# SPARKS STADIUM EVENT PARKING LOT ADDITION

10-22-2025 CITY PERMIT SET SUBMITTAL

## PUYALLUP SCHOOL DISTRICT

SHEET TITLE: **TOPOGRAPHIC SURVEY** SHEET NO. **1 OF 2** PROJECT NO. **19474**

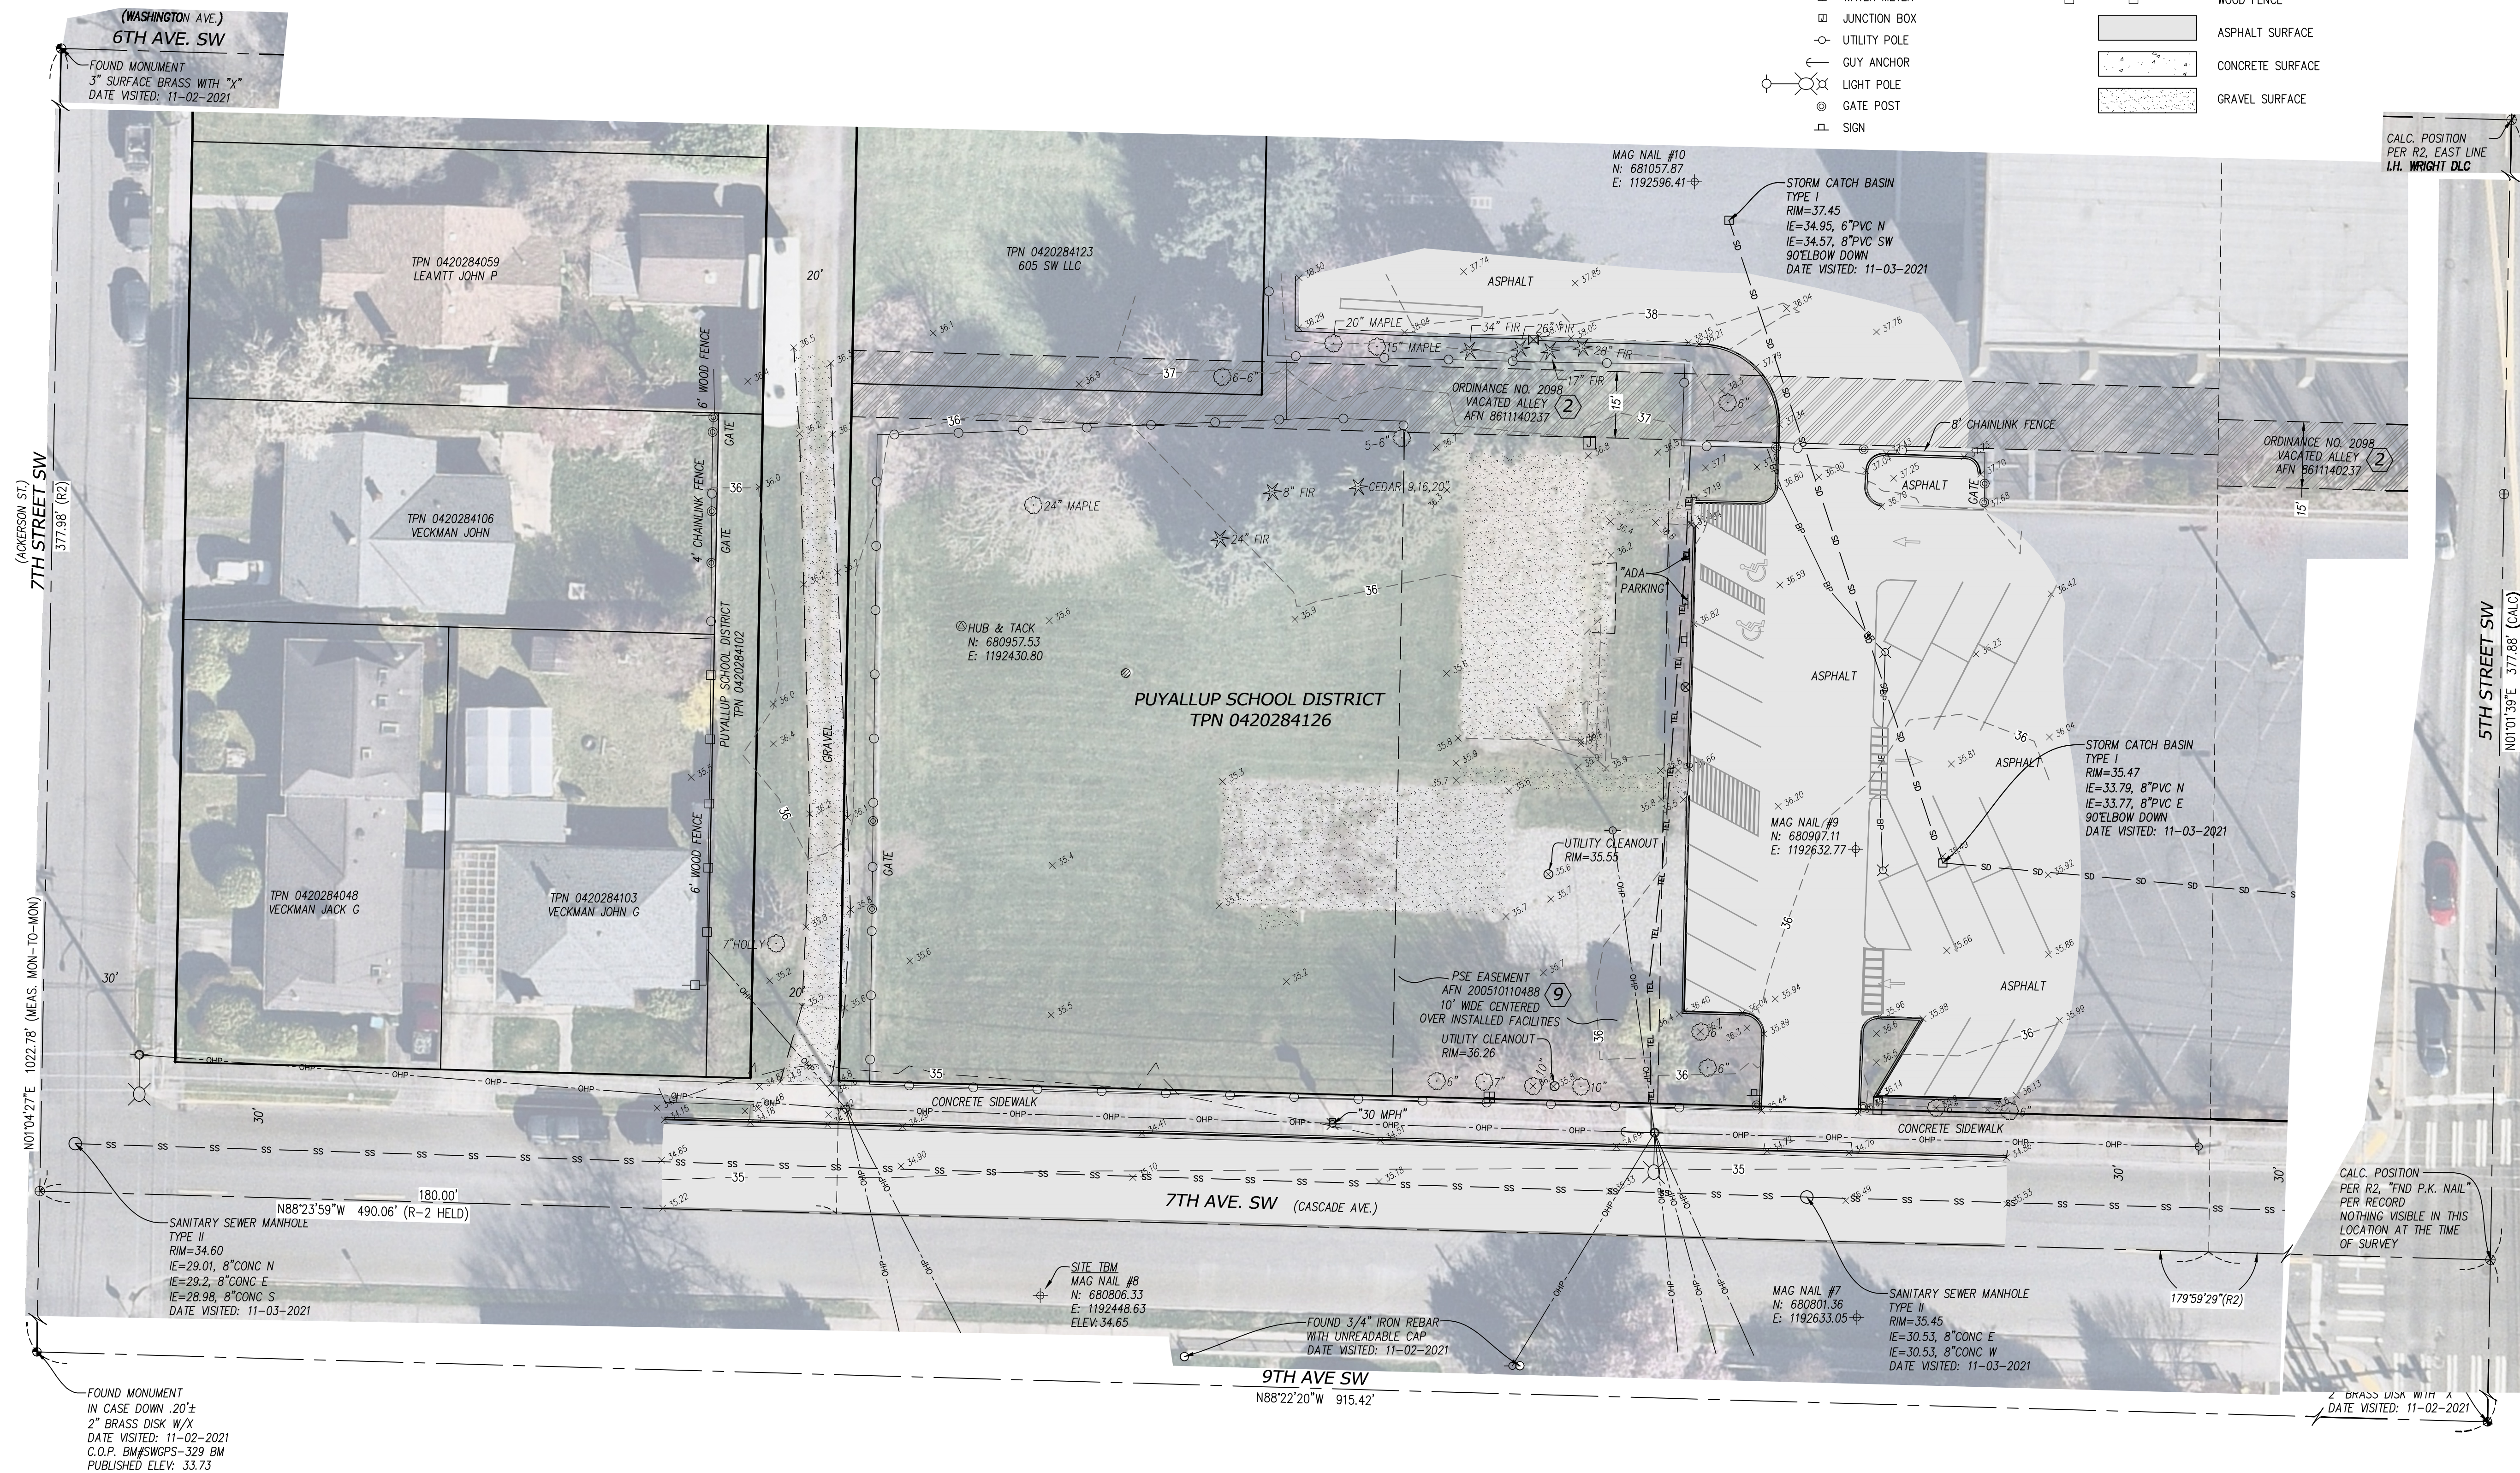
Show easement boundary.

**A4** TREE PROTECTION  
SCALE: B2

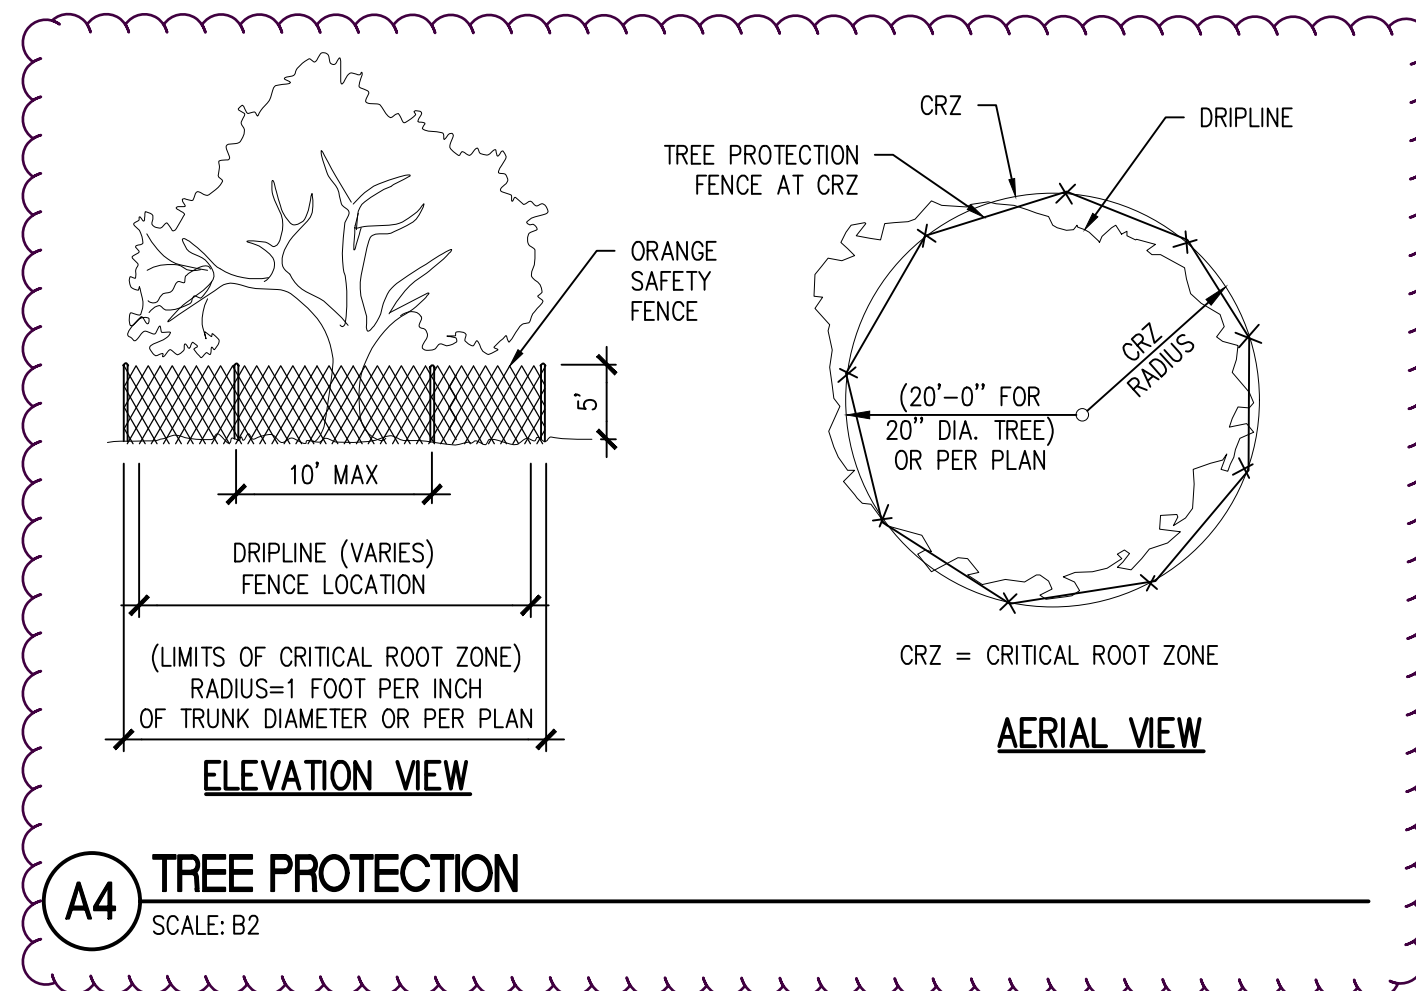
The City of Puyallup requires a minimum height of 6' for tree protection fencing. Please replace the provided diagram with the City of Puyallup's tree protection fencing detail:  
<https://www.google.com/url?sa=t&rc=j&q=&esc=s&source=web&cd=&ved=2ahUKEwj2iYWZ1o6SAXVGAADQIHbQBJyMQFnoECBYQAQ&url=https%3A%2F%2Fpermits.puyallup.wa.gov%2Fportal%2Fpermit%2FgetFile%2F56599&usg=AOvVaw0GsTD17oH3P0Az2UeNsgsC&opi=89978449>  
 See CIVIL PLANS, sheet 10 of 34.

**C1 BOLLARD DETAIL**  
SCALE: N.T.S.

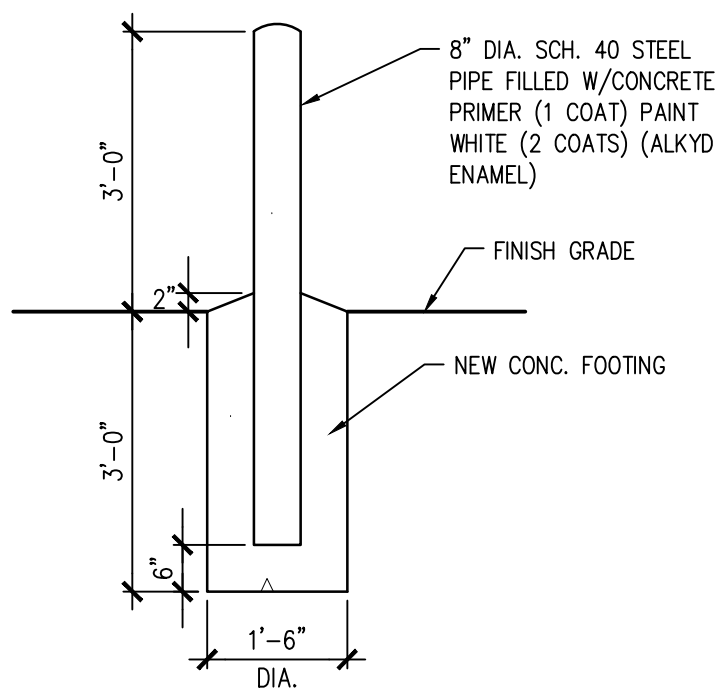
Provide 6 inch sand layer for treatment (See V-6.1: Sand Medium Specification in the 2019 SWMMWW) of the PGHS or demonstrate that the native soils meet the criteria for runoff treatment via V-5.6 Site Suitability Criteria in the 2019 SWMMWW. Revise Detail 3A using Figure V5.1 or demonstrate how the current design is equivalent. Clarify the purpose of the Geoweb grid.

**D1** PIPE GATE - CLOSED ELEVATION  
SCALE: 3/8"=1'-0"

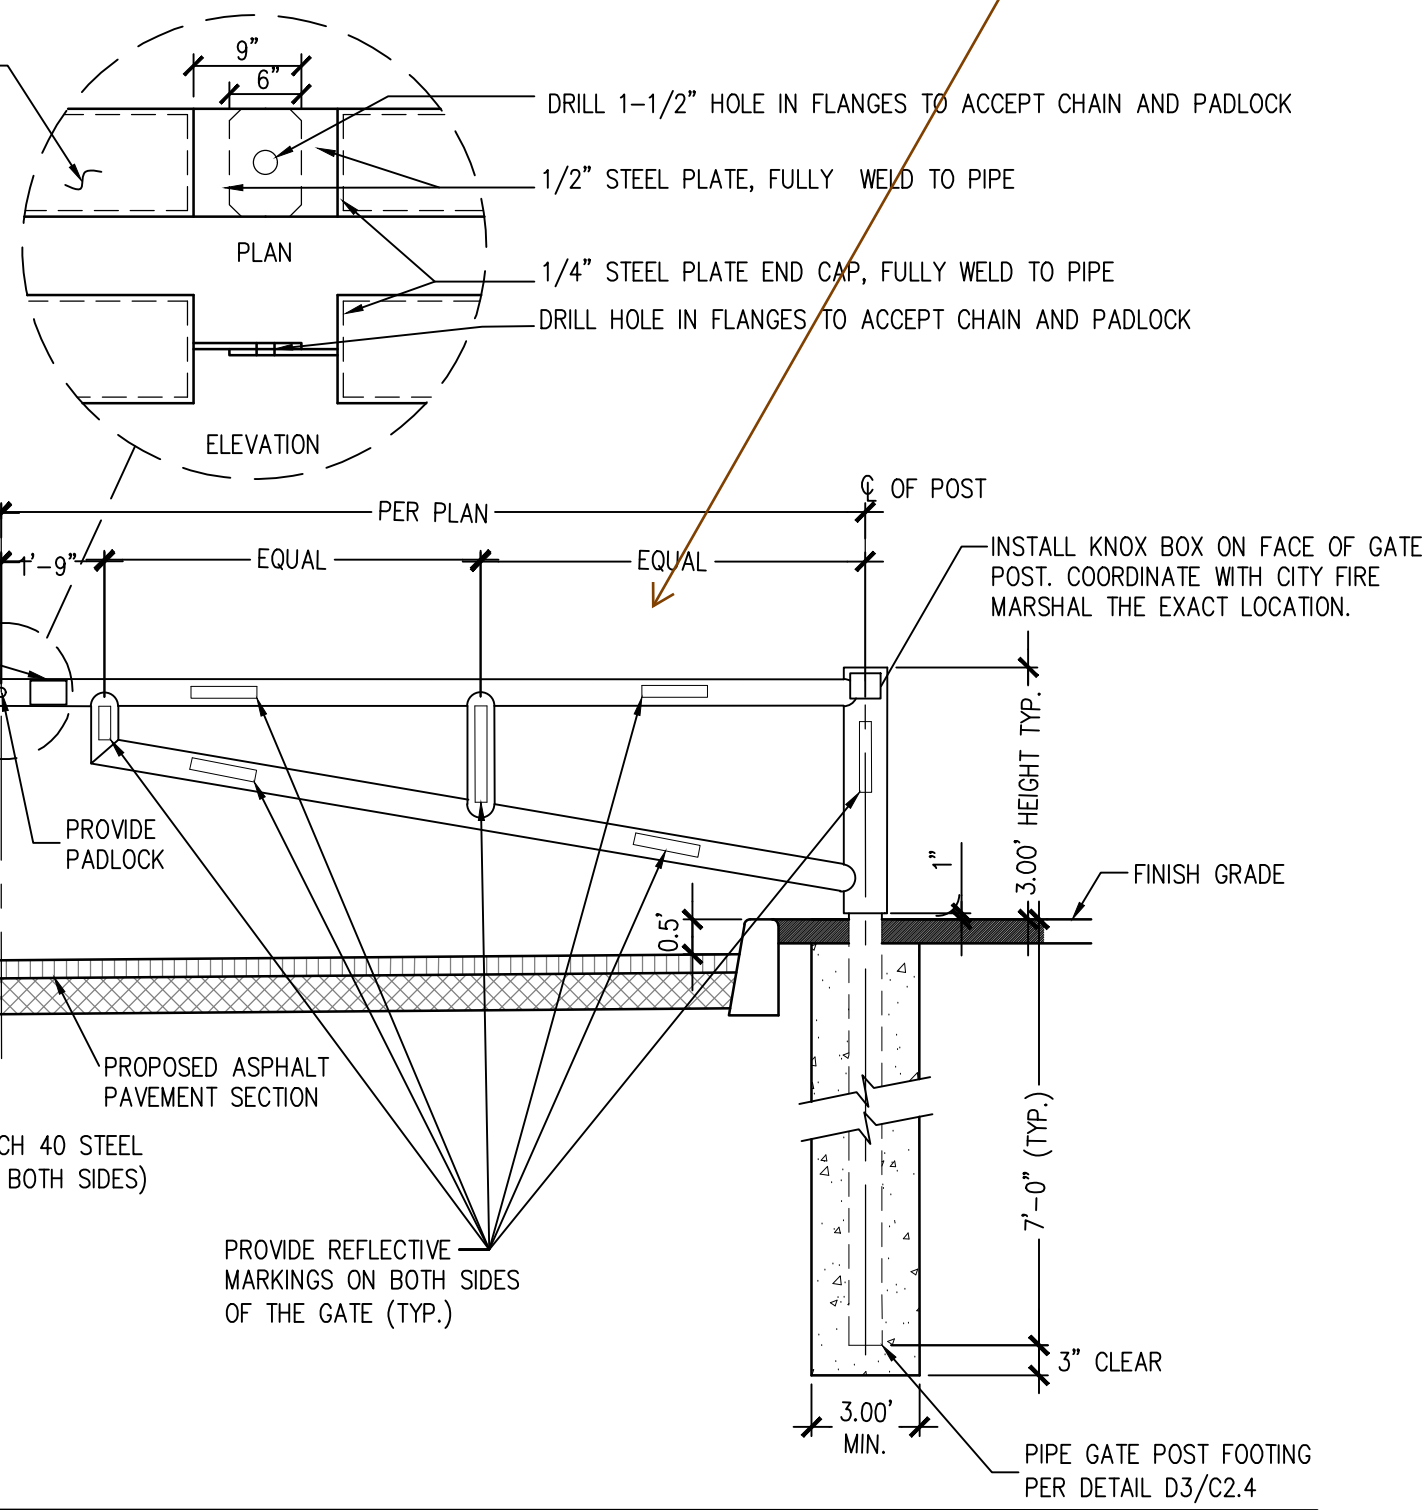
The gates need to be fully retroreflectorized on both sides with vertical stripes alternately red and white at 16-inch intervals measured horizontally. This guidance comes directly from the MUTCD (Section 2B.68). Also, end of roadway object markers (OM4-1) should be installed similar to our Type III Barricade standard (01.01.21). See Sunrise elementary access gates for reference.

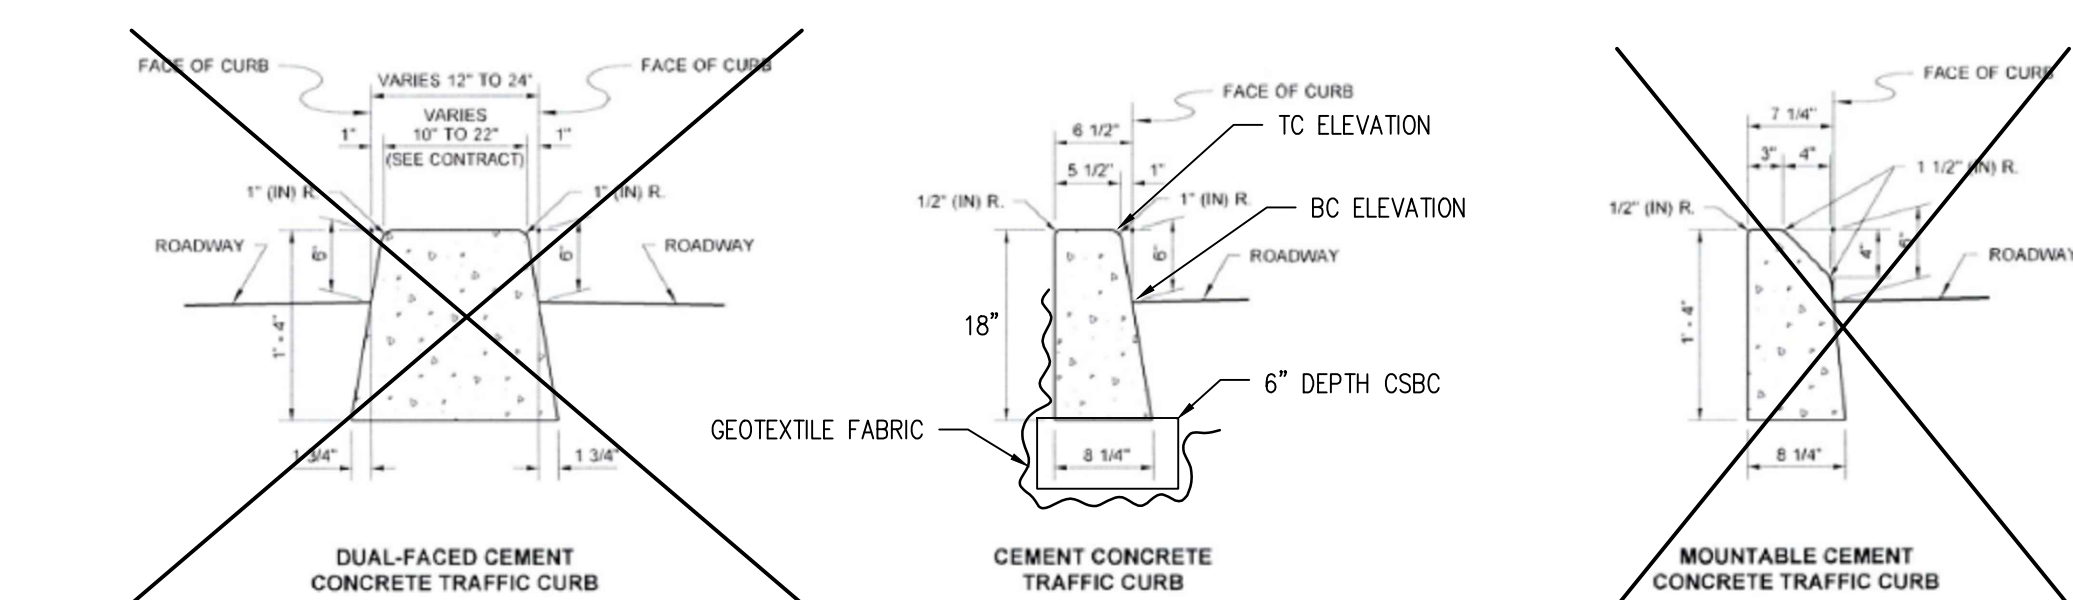
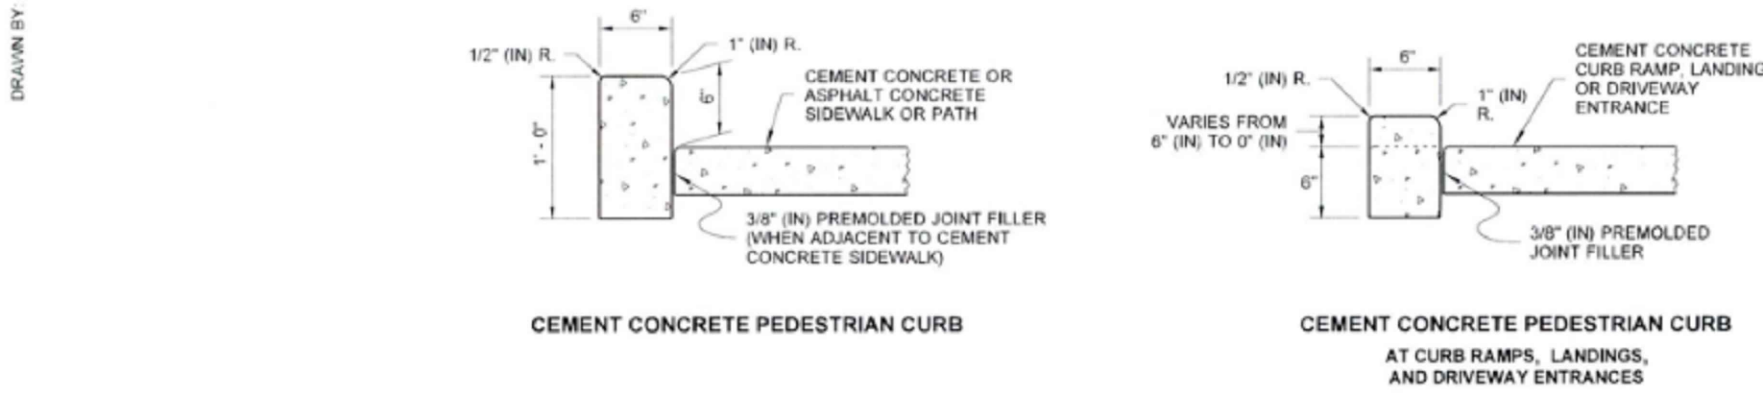
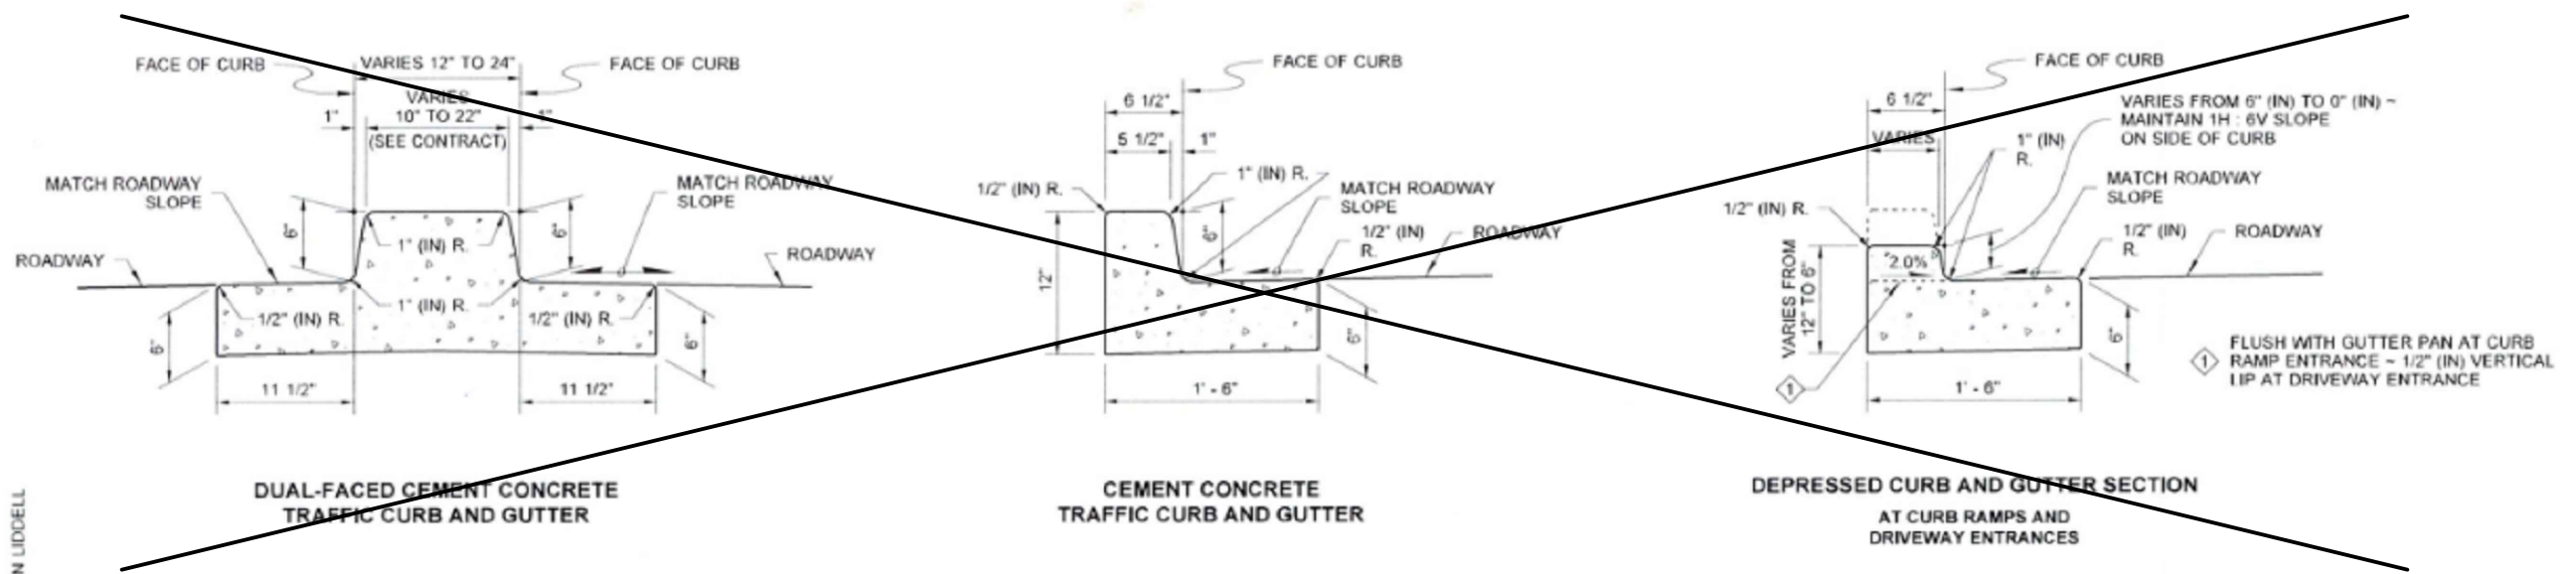
remove marked crosswalk SH sheet C2.7

show power pole or note if relocated SH sheet C2.7

per WSDOT plan F-45.10-05 note #7, if greater than 5' detectable warning should be at curb, this shows 13.31'  
SH sheet C2.7
